WCAP-17788-NP  
Volume 1, Revision 1

# **Comprehensive Analysis and Test Program for GSI-191 Closure (PA-SEE-1090)**

SUBJECT: TECHNICAL EVALUATION REPORT OF IN-VESSEL DEBRIS  
EFFECTS

**TECHNICAL EVALUATION REPORT OF  
IN-VESSEL DEBRIS EFFECTS**

**Figure 6-4  $K_{split}$  as a Function of ECCS Recirculation Flow Rate from Westinghouse Downflow Analysis**

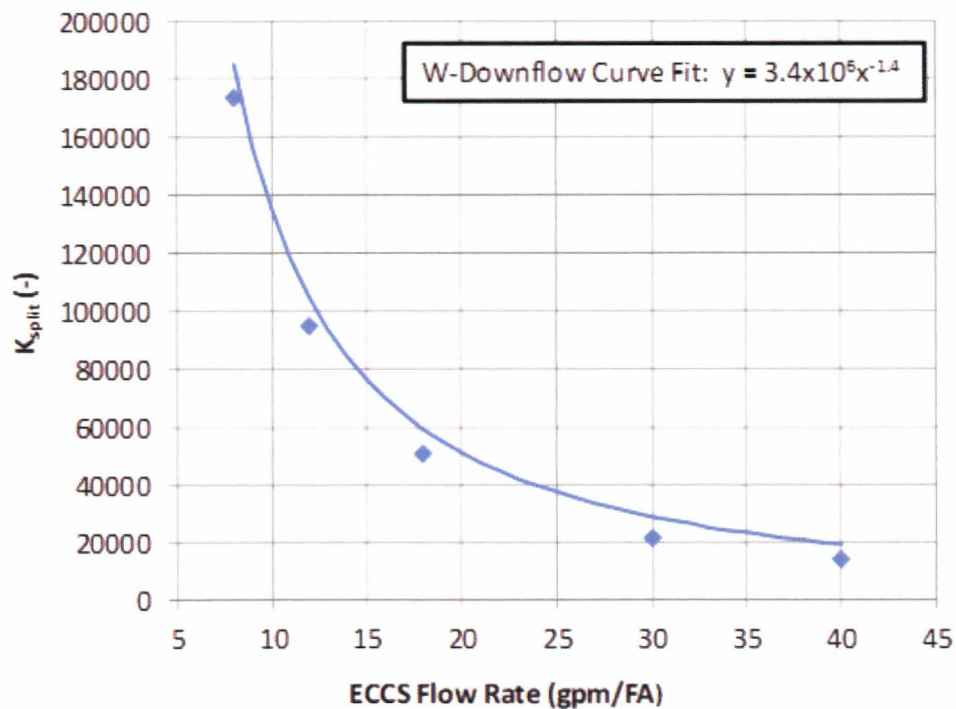
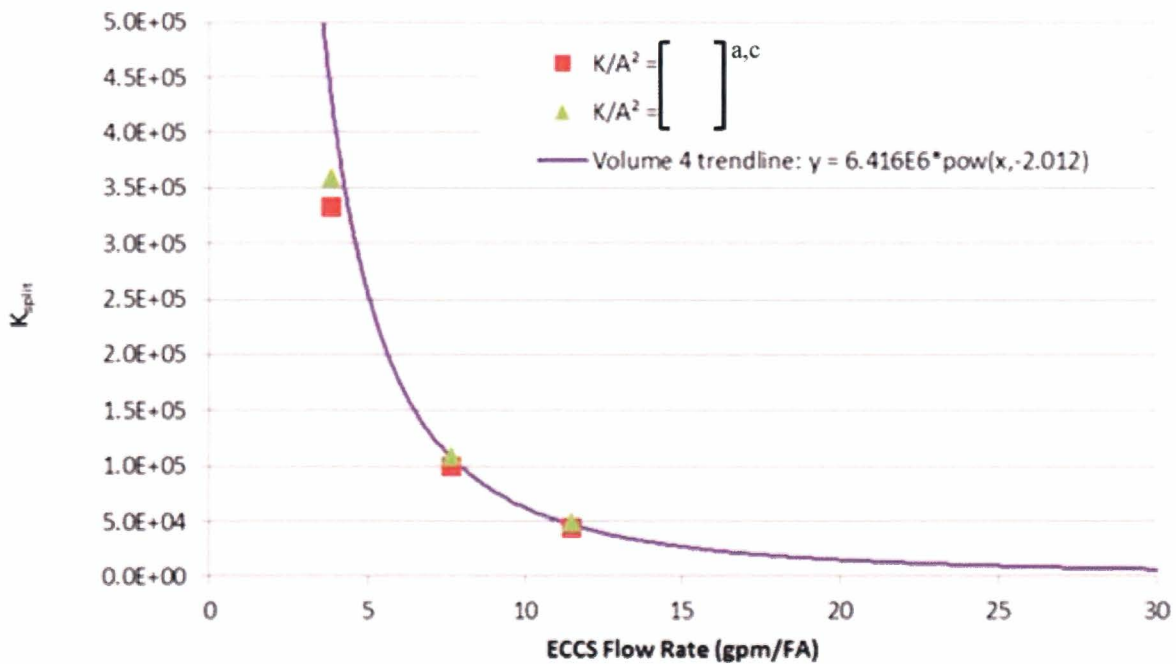
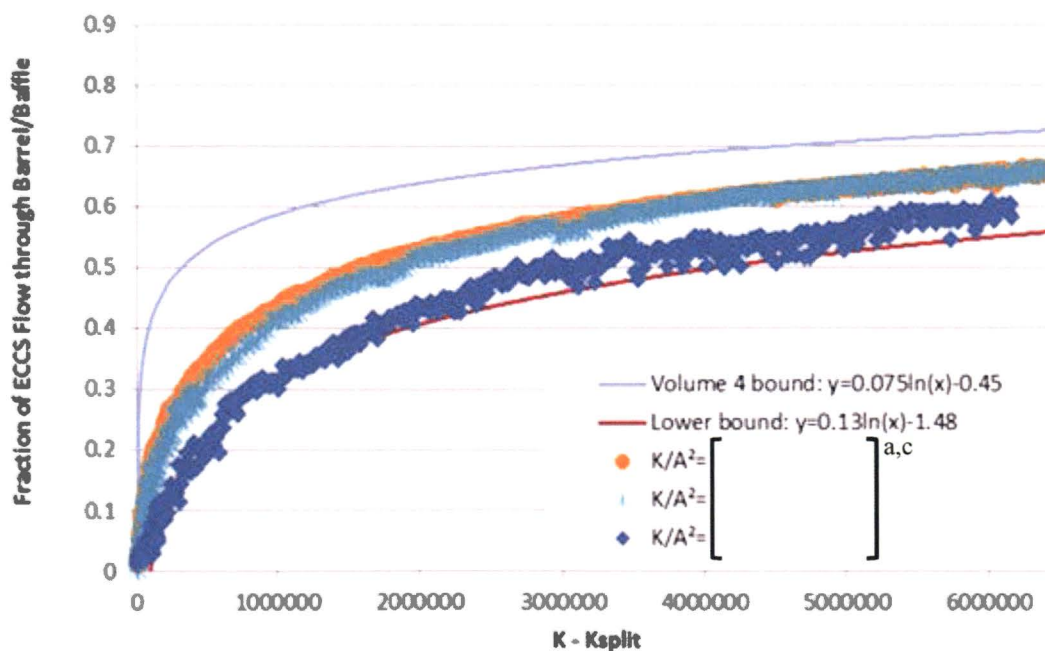
The trends in Figures 6-4, 6-6, and 6-8 show that as the resistance at the core inlet ( $K-K_{split}$ ) increases, the flow through the alternate flow paths increases for various emergency core cooling system (ECCS) recirculation flow rates.

- a. As seen in Figure 6-4, there is a nearly vertical ramp in the fraction of ECCS flow through the upper head spray nozzles (UHSN) at  $K-K_{split}$  of about 10,000 for a flow rate of 40 gallons per minute (gpm) per fuel assembly (FA). What is the reason for this sudden increase in the UHSN flow fraction amounting to about 15 percent of the maximum observed value?

- b. Figure 6-6 shows results of the Combustion Engineering analysis. Explain why the results are widely scattered compared to those depicted in Figures 6-4 and 6-8 where the results show less data scatter for each ECCS recirculation flow rate. Describe the reason for the observed behavior of the 12.5 gpm/FA results in Figure 6-8 associated with a change in the exhibited trends and a steep increase in the barrel/baffle flow fraction for  $K-K_{split}$  between 5,500 and 6,000. Explain why the results in Figure 6-8 contain a significant amount of data points that are considerably different from the general trends, especially in the 2000-4000  $K-K_{split}$  range.

- b. Figure 6-6 from WCAP-17788, Volume 1 was developed from the thermal-hydraulic analyses presented in WCAP-17788, Volume 4. As part of the RAI responses for Volume 4, this figure will be revised and replaced based on additional CE analyses that will be developed in response to RAI 4.20 and 4.21.

Figure 6-8 from WCAP-17788, Volume 1 was developed from the thermal-hydraulic analyses presented in WCAP-17788, Volume 4. As part of the RAI responses for Volume 4, this figure will be revised and replaced based on an updated understanding of the role the alternate flow path plays in the B&W analyses. The reader is directed to the response to RAI 4.20 and 4.21 for the new figure and discussion.

**Figure 7-5 Reactor Vessel Outlet Steam Quality**

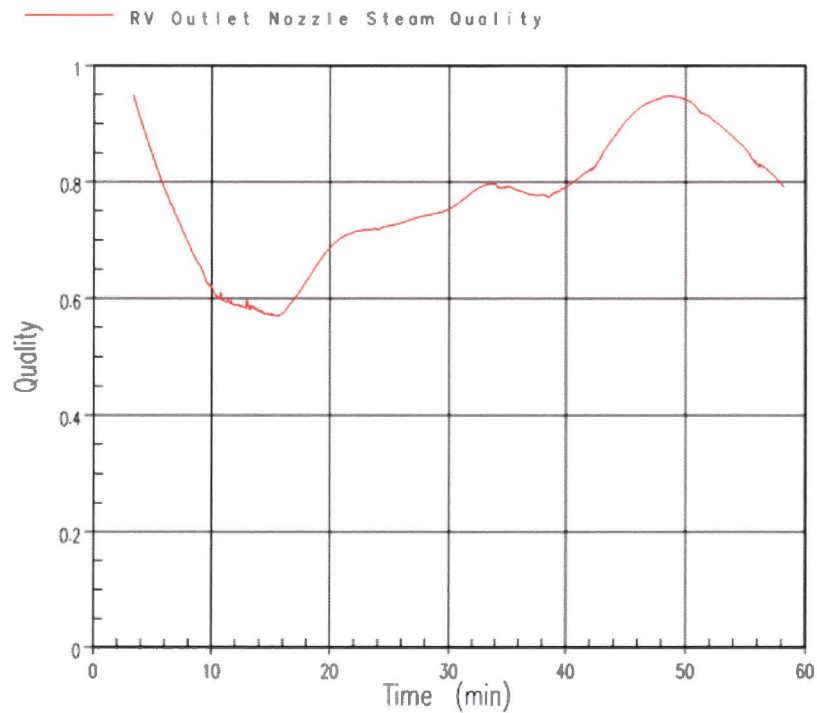
In Figure 7-5 of Volume 1, the exit steam quality does not appear to increase significantly at 45 minutes as might be expected when flow to the core is stopped for 2 minutes during swapover. Also, after swapover, the exit quality might be expected to be higher because the temperature of the coolant being injected to the core is assumed to be higher. Discuss the trend in exit quality with respect to these observations. Will these results be used as justification for crediting entrainment?

Figure RAI-3.29-1 Error in Brine Test Inlet Flow Rate from Test T029

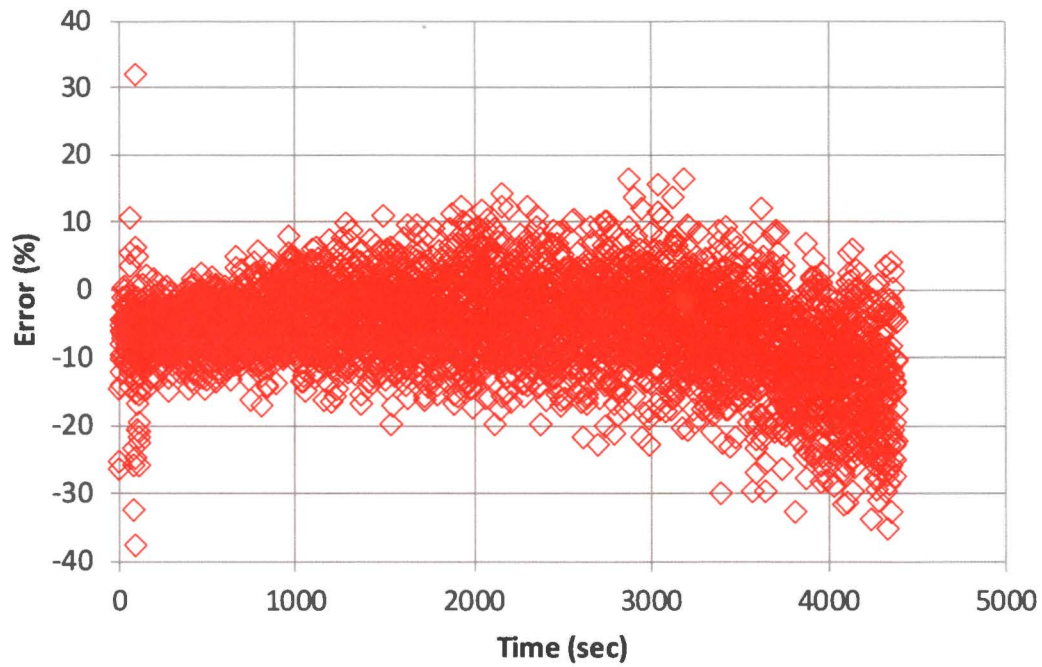
- a. Identify the DH model used to scale the test flow curves in Figure 5-5 and clarify whether the uncertainty in the model was accounted for (e.g., using a 1.2 multiplier).

Where  $Q_{test}$  is the calculated inlet flow rate from the test, and  $Q_P$  is the predetermined flow curve based on decay heat. The error is calculated for brine test T029. The measured outlet flow rate, brine injection flow rate, and calculated inlet flow rate from this test are shown in Figure 7-8 of PWROG-15091-P. The predetermined flow curve for this test is Flow Control 2 shown in Figure 5-5 of PWROG-15091-P. The uncertainty associated with the inlet flow rate ( $\pm 0.006$  gpm) is not included in the error calculation since it is small compared to the inlet flow rate. Figure RAI-3.29-1 shows the error between the test inlet flow rate and the predetermined flow curve used in the testing for brine test T029. As the figure shows, the majority of inlet flow data points fall within a range of +20% and -30% of the predetermined flow curve.
